UNITED STATES
NUCLEAR REGULATORY COMMISSION
WASHINGTON, D. C. 20555

NRC STAFF EVALUATION OF SITE STABILIZATION PLAN FOR
YELLOW CREEK NUCLEAR PLANT, UNITS 1 & 2
DOCKET NOS. STN 50-566 AND 50-567

YELLOW CREEK NUCLEAR PLANT
 CANCELLATION PLAN
 FIGURE 1

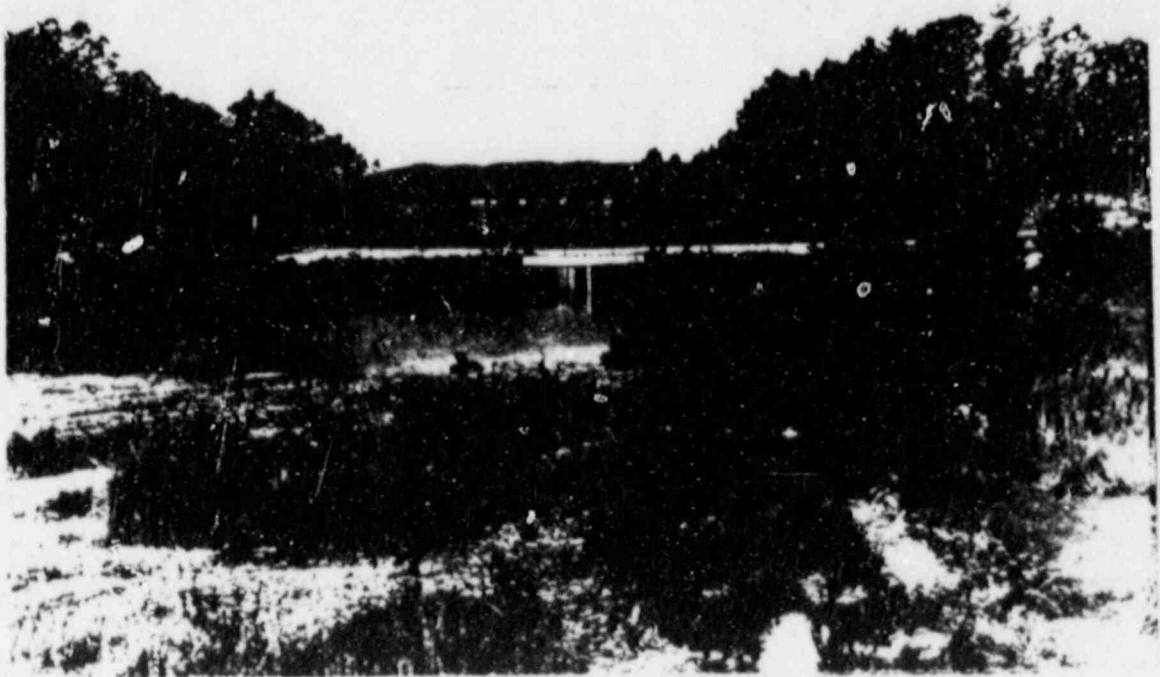
The TVA site stabilization plan transmitted by its October 24, 1985 letter provides for the stabilization of the site by grading, revegetation and the use of holding ponds to limit erosional runoff until revegetation is completed (See Figure 1). It also provides for control of unauthorized access and prevention of unauthorized use. The plan will remain in effect until the most appropriate long-term use of the site is determined, at which time it will be incorporated into that use.

During the site visit of May 21, 1986, the entire site was inspected. Much of the grading and seeding had already been completed. All of the rainfall runoff from the site drains through the three holding ponds shown in Figure 1, and thus there will be little if any erosional runoff into Pickwick Lake even prior to completion of the revegetation program. Photographs were taken during the site visit. These photos show the condition of the site at that time and that some of the regrading and seeding has already been completed.
